Review of Design, Construction and Repair of TCRA Armoring for West Berm of San Jacinto Waste Pits

FINAL REPORT--October 2013

Prepared for U.S. Environmental Protection Agency, Region 6

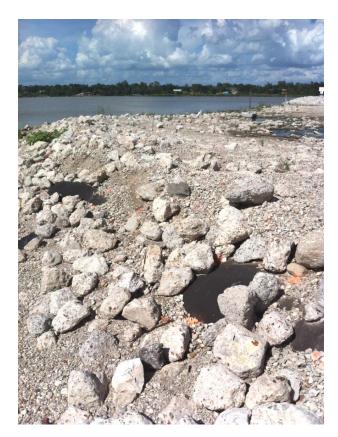
This review of the design and construction of TCRA armoring for west berm of San Jacinto Waste Pits, TX is being conducted to address the performance of the armoring during a recent flood/storm event estimated to be a 10-year return event. Following the event, considerable movement or loss of armor material was discovered as evident in Figures 1, 2, 3 and 4.

Armor caps can be designed in three manners: 1) traditional with a base layer, filter layer and armor layer, 2) a graded armor layer (blended filter-sized stones and armor size stones) over the base layer, and 3) a base layer, geotextiles filter and armor layer. The first option is the common method for shallow marine construction; the second option is becoming a common option for deep water environments with shallow slopes; and the third option is commonly applied on shorelines with moderate to steep slopes. At San Jacinto the armor cap was designed with options 2 and 3 or a combination of options 2 and 3. Cap Configuration A consisted of geotextile placed on the base layer for constructability and then capped with blended armor and filter stones. The filter material also provided a bedding to protect the geotextiles from puncture by armor stone during construction. Cap Configurations B, C, D and E in the Final Removal Action Work Plan, Appendix A: TCRA Technical Specifications (September 2010) do not call for the use of armor stone blended with filter stone. Nevertheless, Figures 1 through 4 show a large quantity of gravels and sand in the Cap B/C, resembling a blended filter.

The armor stone specification is not well specified. The TCRA Technical Specifications, Appendix A (Anchor QEA November 2010) and USA Submittal 10 (Anchor QEA Feb 2011) cite only that 100% of the stones passes 12 inches with no more than 50% passing 6 inches and no more than 4% passing the #200 sieve. The armor stone should have had a specification of no more than 10% passing 2 inches to improve the uniformity and stability. The pictures in Figures 1 through 4 show an excessive quantity of gravel and sand size particles.

The slope of an armored bank should not generally exceed 1V:2H and in an area with overtopping and waves breaking should not exceed 1V:3H. Appropriately, the slope of the west berm was designed to be no more than approximately 1V:3H; however, Figures 2, 3 and 4 show slope sections that appear to be as steep as 1V:1H. The face of the berm shown in these pictures should have been filled with bedding material to ensure that all slopes were no greater than 1V:3H where high velocities, waves and overtopping may occur.

The use of blended stones in locations of steep to moderate slopes (greater than 1V:3H) at velocities greater than 1.3 m/s is not recommended. The filter size stones will rearrange themselves and move down the slope, vacating areas at the top of the slope until a stable slope is achieved under the given shear stress. As the filter stones vacate areas, the voids created will make the armor stones unstable as well and cause them to relocate down the slope as well. Velocities were predicted to be as large as 1.98 m/s in the southwestern corner of the berm. Therefore, the armor stone should have been graded (screened) to limit the quantity of filter size stone and increase the uniformity of the armor stone. Repair of the west berm with Armor Cap C material is appropriate.

- 4. Repair should ensure that the final surface throughout the repair area and adjacent areas has a slope of 1V:3H or flatter.
